**PLAN COMMISSION MEETING
IN PERSON AND VIA ZOOM
TUESDAY, NOVEMBER 4, 2025 – 6:30 PM
CITY HALL – SECOND FLOOR**

SITE PLAN REVIEW REPORT TO THE PLAN COMMISSION

PROPERTY ADDRESS: 1200 Industrial Dr.

FILE NUMBER: SPR-2025-29

PROJECT INFORMATION

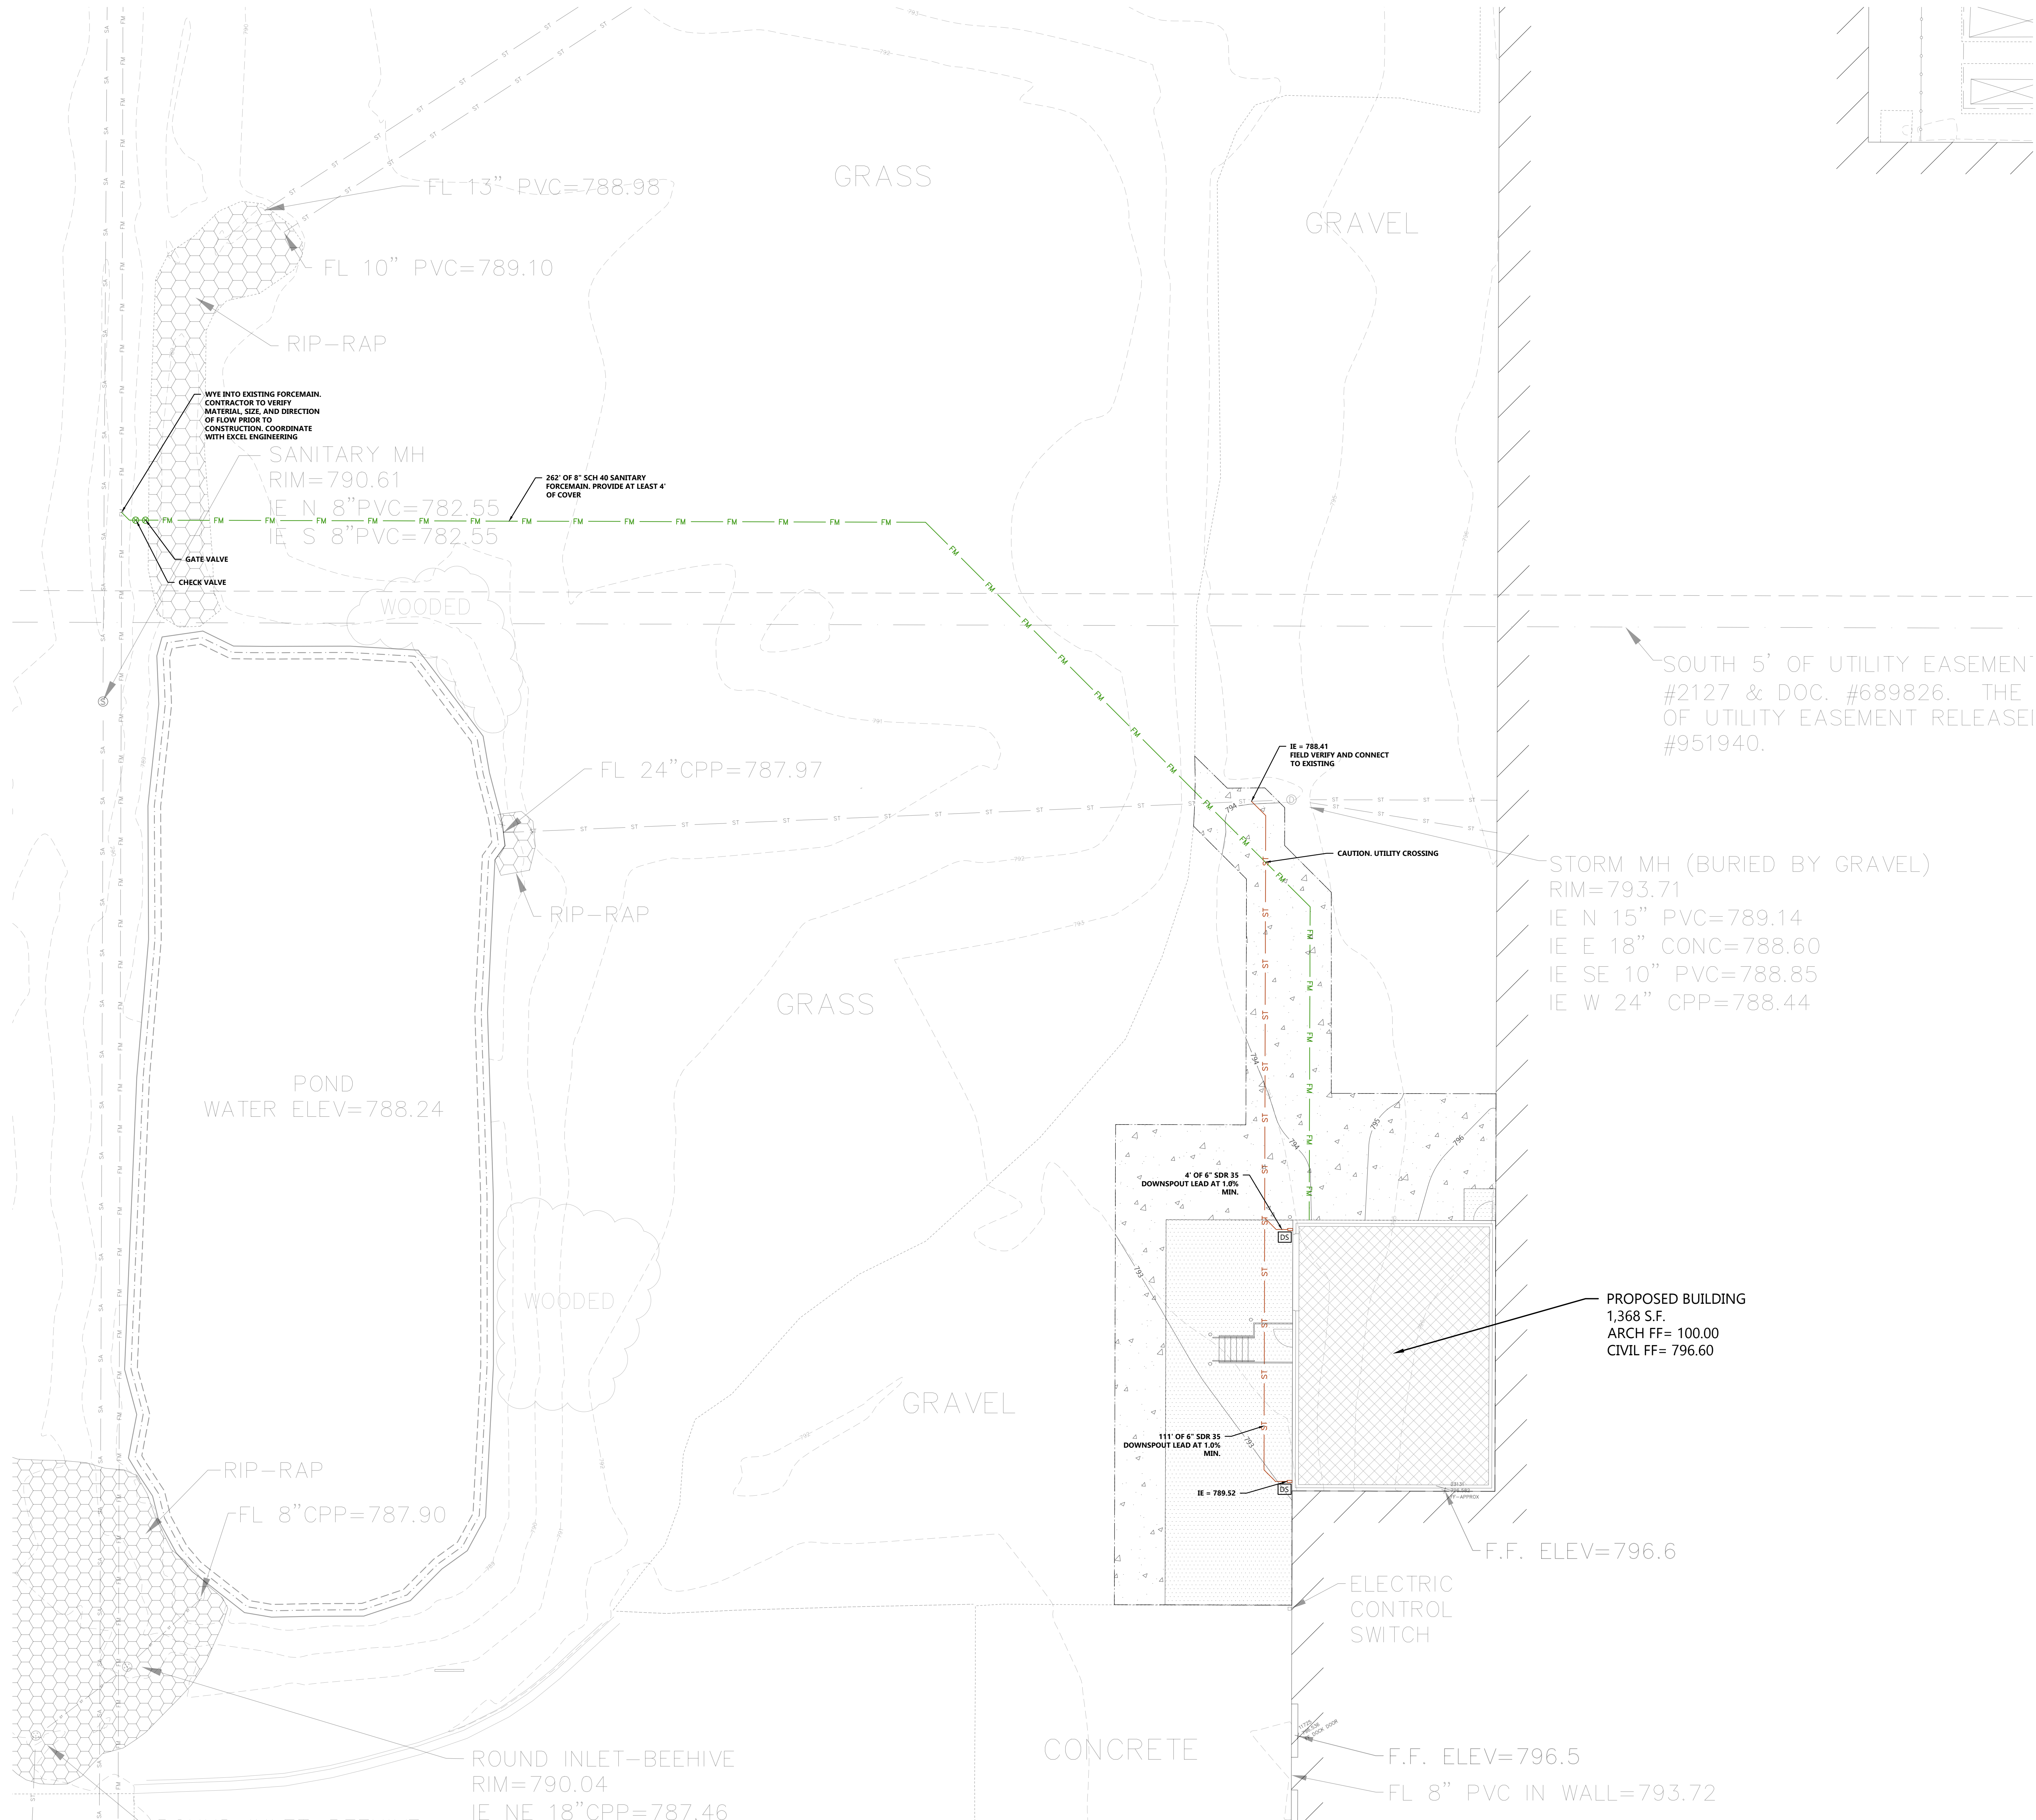
- No change proposed. No requirements are applicable to this project.
 1. There is approximately 40' between the proposed building addition and existing edge of the gravel driveway. This provides adequate space to move vehicles around the building addition within the existing, internal gravel driveway.
 2. There is approximately 70' between the front of the proposed building addition and the existing edge of the gravel driveway. This provides adequate space to conduct loading/unloading within the existing, internal gravel driveway.

- 0 landscaping points are required for the street frontage = Not applicable
- 0 landscaping points are required for the paved surface areas = Not applicable
- 23 landscaping points are required for the building foundation = **Not Met (none provided)**
- 14 landscaping points are required for the yards = **Not Met (none provided)**

to locate building foundation landscaping points surrounding the structure because of the design and existing surrounding impervious surfaces. An alternative location on the site could be utilized to satisfy the landscaping requirements and the total point value required (37 points) could be met through the addition of one canopy tree on the site. The Plan Commission can determine if the point values required could be met in an alternative location of the site.

The proposed project does not create additional impervious surfaces and does not require additional storm water management. It should be noted it has been observed that there are erosion control concerns with the ditches, culverts, and aprons on the site, resulting from stormwater runoff and current maintenance practices. The use of grass and weed control chemicals in the ditches has contributed to erosion and requires repairs to the ditches and aprons.

- Provide required Landscaping points in an alternate location in the Front or Street Yard.
- Parking areas to be paved in an approved method or cease to be used for the parking of vehicles or semi-trailers.
- Raise the existing Stormwater manhole to the new grade.
- Restore existing ditches and aprons damaged by stormwater leaving the site.
- Any other comments by the Plan Commission.
